WARRANTY BULLETIN

Wb06-03

SUBJECT: ADDITION OF A RELAY ON THE LAVATORY FAN

CIRCUIT (XLII WITH ZF-ASTRONIC

FIGURE 1: REAR JUNCTION BOX

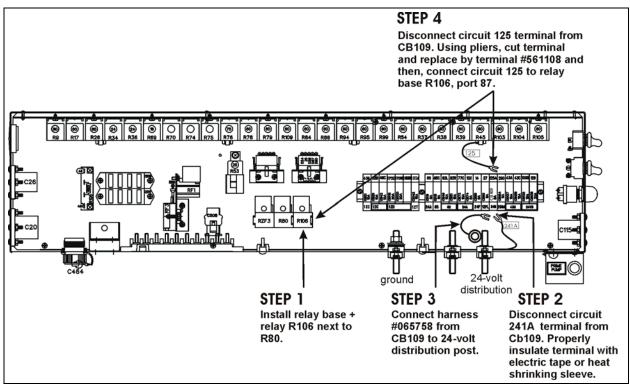
- 1. Inside engine compartment, open rear junction box.
- 2. Follow steps 1 to 7 on figure 1 and 2.
